QUALITY ASSURANCE -- NON-CONFORMANCE REPORT

Location: Changxing Island, Shanghai, P.R. China**Report No:** NCR-000866**Prime Contractor:** American Bridge/Fluor Enterprises, a JV**Date:** 17-Oct-2010**Submitting Contractor:** Zhenhua Port Machinery Company, Ltd (ZPMC), Changxing Island**NCR #:** ZPMC-0828**Type of problem:**

| Subject: | NCR No. ZPMC-0828 | Document No: | 05.03.06-000823 |

Subject: NCR No. ZPMC-0828

LONGITUDINAL DIAPHRAGM SUB-ASSY ~ MARK LD3028A
(TYPE 2) (E3, LOOKING NORTH - DEVELOPED)

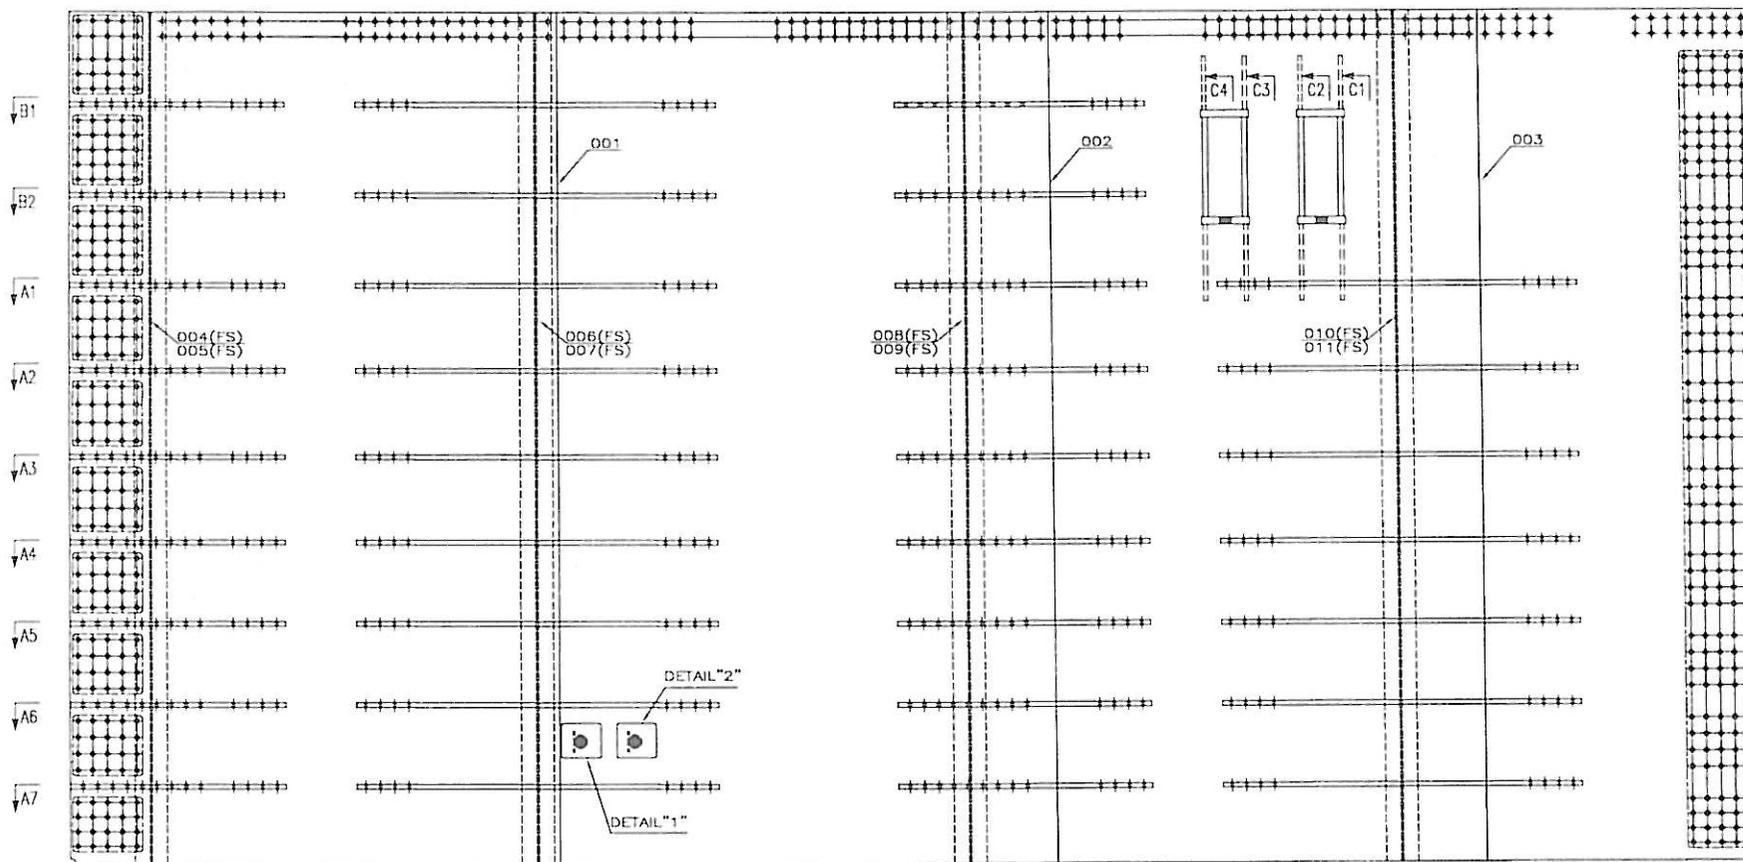
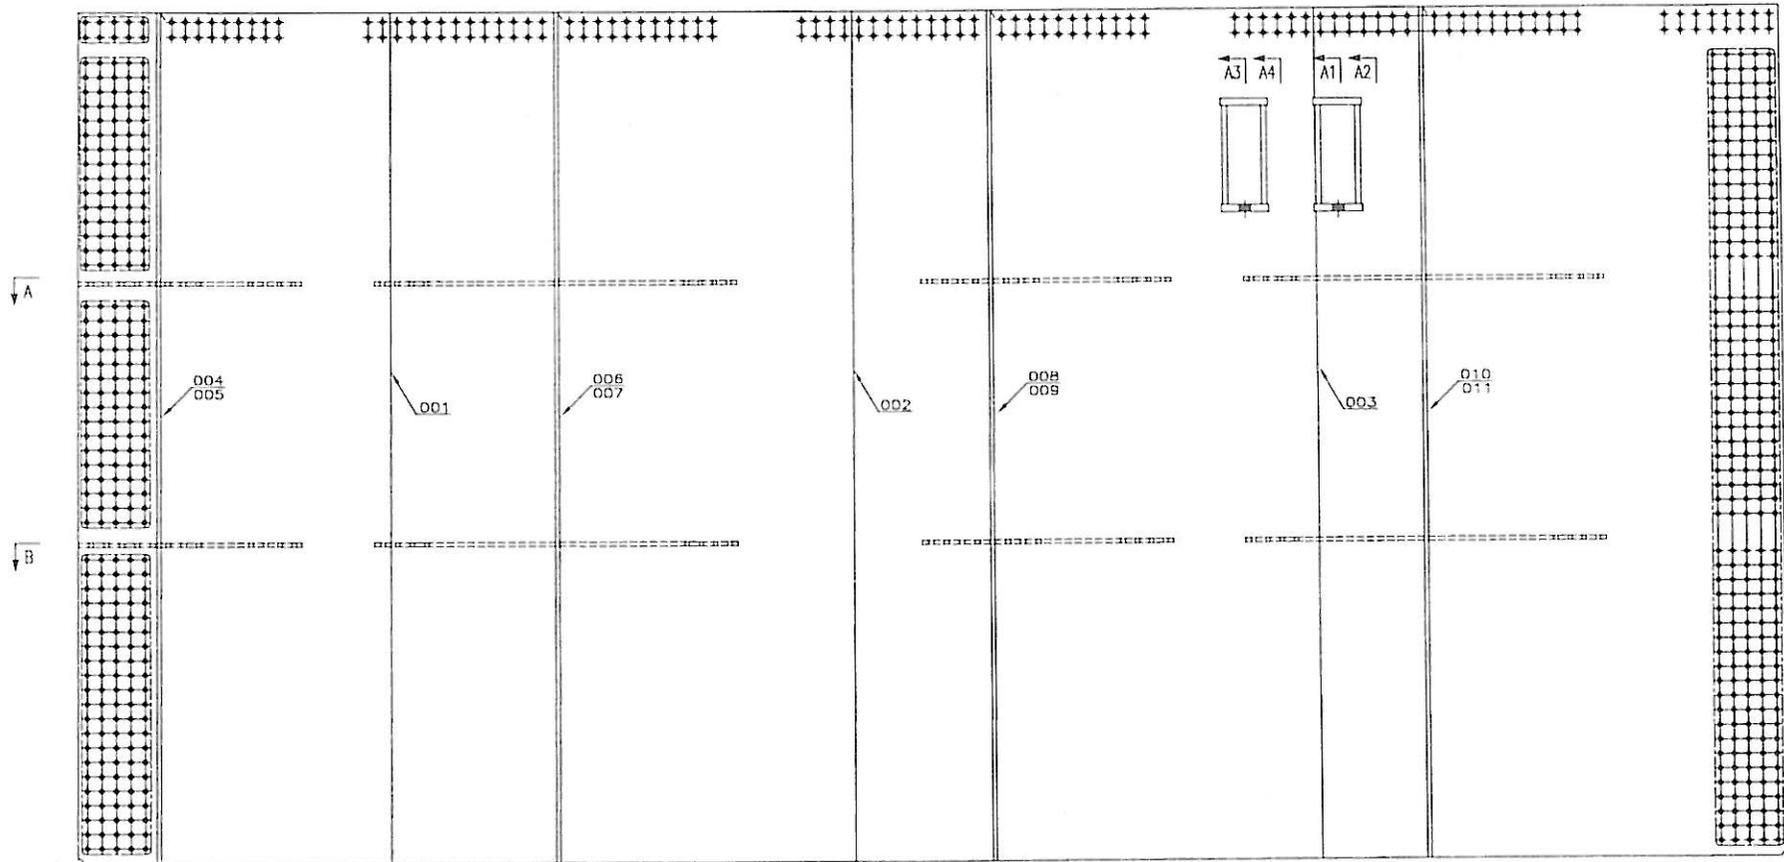
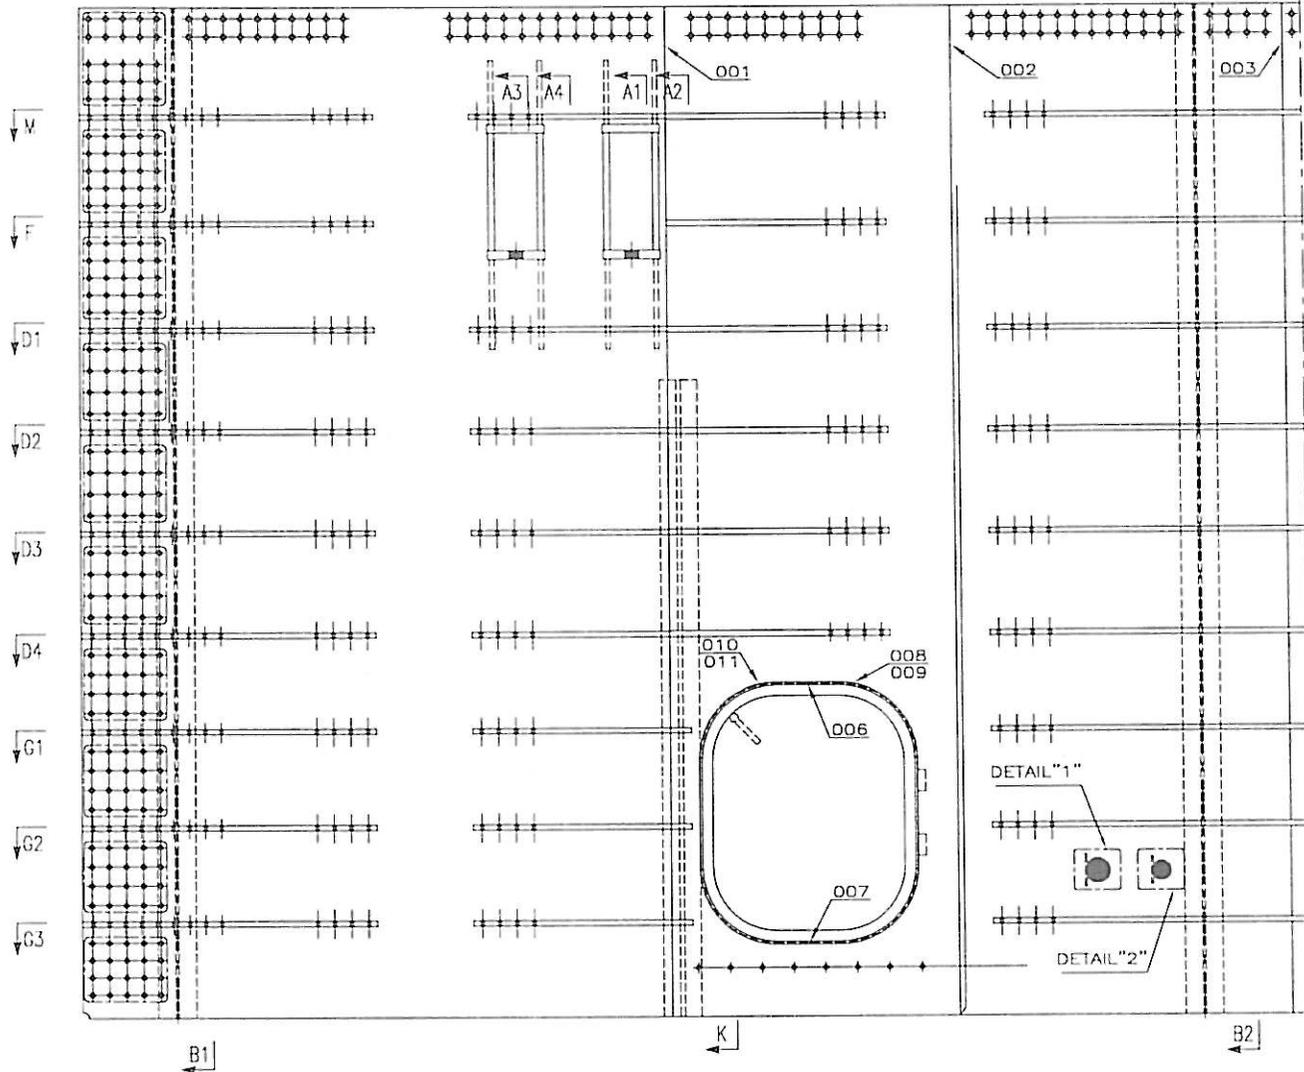
During the Quality Assurance (QA) Ultrasonic Testing (UT) review of welds located on Orthotropic Box Girder (OBG) segment 13BE and 13CE, this QA Inspector discovered the following issues:

- Three (3) longitudinal linear class "A" rejectable indications measuring approximately 180mm~260mm in length.
- The welds are identified as LD3028-001-031, LD3027-001-026 and LD3030-001-053.

- Material thickness for all joints is 30mm.
- The indication db rating for joint LD3028-001-031 is a +6.
- The indication db rating for joint LD3027-001-026 is a +4.

- The indication db rating for joint LD3030-001-053 is a +5.
- The depth of the indications are from 20mm~23mm deep.
- The Weld LD3028-001-031 is joining longitudinal diaphragm (X3682A) to lifting Lug.

- The Weld LD3027-001-026 is joining longitudinal diaphragm (X3684B) to lifting Lug.
- The Weld LD3030-001-053 is joining longitudinal diaphragm (X3685A) to lifting Lug.

- All Welds are Complete Joint Penetration (CJP) "T" joint.
- All welds are Seismic Performance Critical Members (SPCM).
- The Y distance for joint LD3028-001-031 is 110mm from bottom cope hole.

- The Y distance for joint LD3027-001-026 is 40mm from bottom cope hole.
- The Y distance for joint LD3030-001-053 is 700mm from bottom cope hole.
- The indications are clearly marked on or near the weld.

These welds were designated to be PJP welds and no UT is required. The NWIT were submitted due to the internal fault between the floor QC & NDT operator of ZPMC. ZPMC is providing the MT records to show the acceptance of these welds and is requesting closure of this NCR.

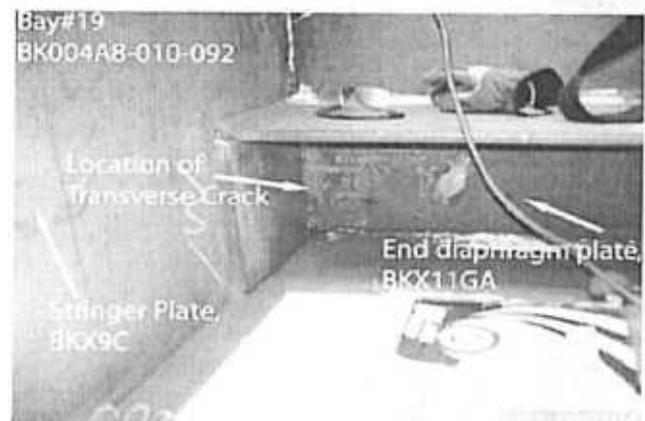
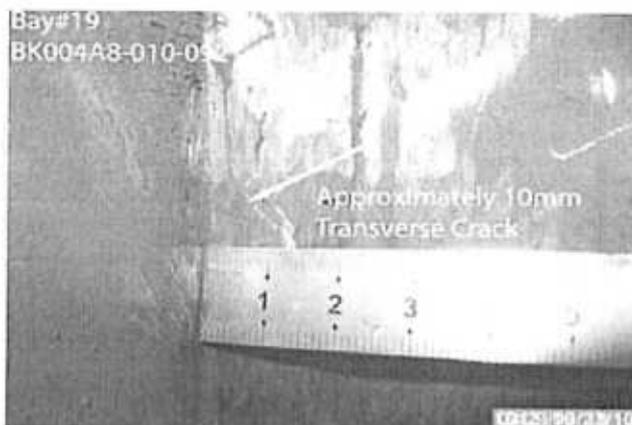
During the Quality Assurance (QA) Magnetic particle Testing (MT) review of welds located on OBG Bike path BK004A-010, this QA Inspector discovered the following issue:

- One transverse crack that measured approximately 10mm in length.
- The weld is identified as BK004A8-010-092.
- The weld is a Partial joint penetration (PJP) T joint, joining the Stringer plate (BKX9C) to the End diaphragm plate (BKX11GA).
- The Y Location is 100mm from the bearing plate.
- The OBG Bike path is located in BAY#19.
- This crack is clearly marked on the material on/near the weld.
- This weld joint is designated as Non-Seismic performance critical (Non-SPCM) weld member.
- The Notice of Witness Inspection Number (NWIT) is 006731.
- The crack is located within the area that has been re-tested and accepted by ZPMC Quality Control (QC) subsequent to the heat straightening procedure.

ZPMC acknowledged the indication was missed and has issued an internal NCR to address this problem. ZPMC has repaired the indication and is providing the NDT record to show the acceptance of this weld. Based on this, ZPMC is requesting closure of this NCR.

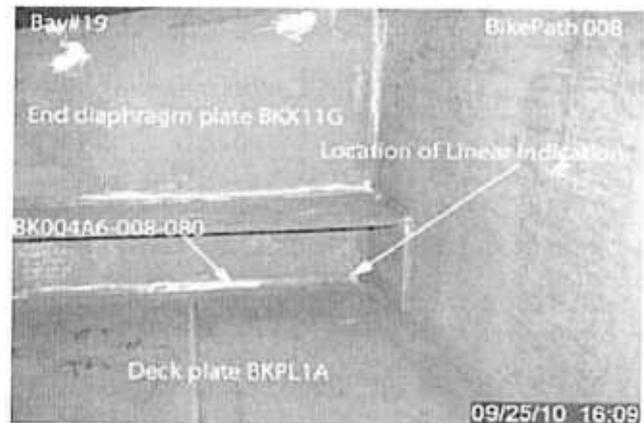
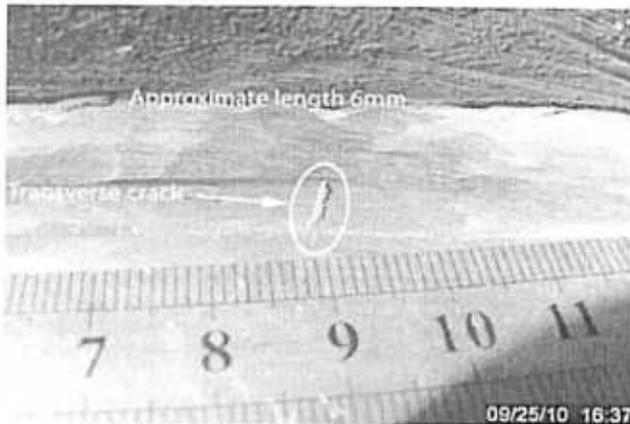
During the Quality Assurance (QA) Magnetic Particle Testing (MT) review of welds located on Bike Path 008, this QA Inspector discovered the following issues:

- One Longitudinal linear crack in the weld measuring approximately 15mm in length.
- The weld is identified as BK004A6-008-080.
- The weld is partial joint penetration (PJP), joining the End Diaphragm plate identified as BKX11G to the Deck Plate identified as BKPL1A.
- This weld joint is designated as Non-Seismic performance critical (Non-SPCM) weld member.
- The crack is clearly marked on the material near the weld.
- The OBG Bike Path 008 is located in Bay #19.

Quality Assurance (QA) Magnetic Particle Testing (MT) review of fillet welds located on OBG bike path BK004A-018, this QA Inspector discovered the following issues:

- One (1) transverse crack found on the weld measuring approximately 6mm in length.
- Y location of the indication is measured to be 2160mm.
- The crack is clearly marked on the weld joint.
- The weld is identified as: BK004A3-018-052.
- The Weld is a fillet weld joining the stringer plate (8C) to the deck plate of bike path.
- The member is located in bay 11.

ZPMC acknowledged the indications were missed and has issued an internal NCR to address this problem. ZPMC has repaired the indications and is providing the NDT records to show the acceptance of the welds. Based on this, ZPMC is requesting closure of this NCR.

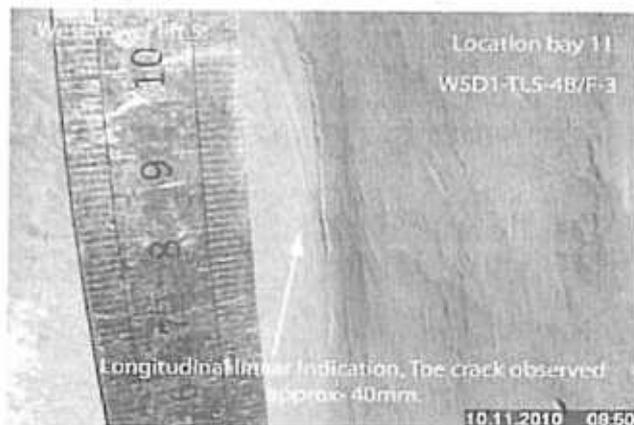
During the Quality Assurance (QA) Magnetic Particle Testing (MT) review of welds located in West Tower lift 5 Grillage plate, WSD1-TL5-4B/F-3, this Quality Assurance (QA) Inspector discovered the following issues:

-One longitudinal toe crack measuring approximately 40mm in length.

-The weld is identified as: WSD1-TL5-4B/F-3.

-The Weld is a Complete Joint Penetration (CJP) weld, joining the grillage plate to skin plate.

-The Notice of Witness Inspection Number (NWIT) is 06917. The indication is located on CJP weld area that has been previously tested and accepted by ZPMC Quality Control (QC) personnel. As per the contract documents, ZPMC's QC personnel are required to perform 100% MT inspection of this weld. The attached photographs provide additional detail.

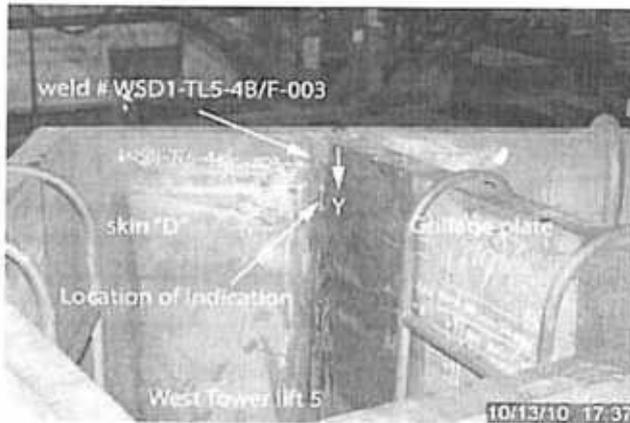
During the Quality Assurance Ultrasonic Testing (UT) verification of welds located on grillage plate of West Tower lift 5, this Quality Assurance (QA) Inspector discovered the following issues:

- One class "A" longitudinal indication measuring approximately 50mm in length.
- The depth of the indication is 57mm.
- The db rating is -2.
- The material thickness is 65mm.
- The weld is identified as: WSD1-TL5-4B/F-003.
- The Weld is a Complete Joint Penetration (CJP) with steel backing, T-joint, joining the grillage plate to the skin plate (skin "D").
- The "Y" location of the indication is 110mm from top side
- The indication is clearly marked on the component.
- The member is located in Bay 11.

The Notice of Witness Inspection Number (NWIT) is 06938. The indication is located inside the area that has been previously tested and accepted by ZPMC Quality Control (QC) personnel. As per the contract documents, ZPMC's QC personnel are required to perform 100% UT inspection of this weld.

-Attached photographs provide additional location details.

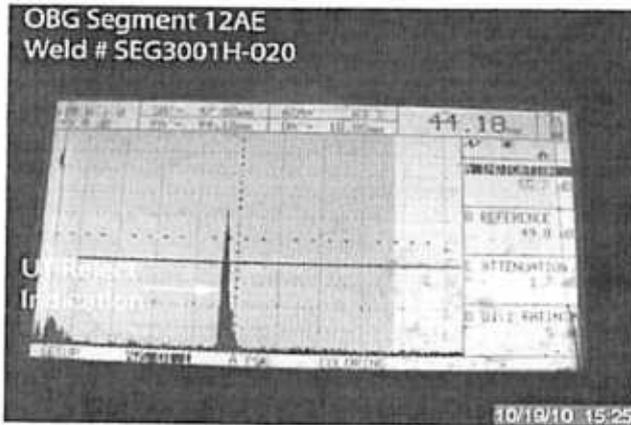
During the Quality Assurance (QA) Ultrasonic Testing (UT) verification of weld located on Segment 12AE, this QA Inspector discovered the following issue:
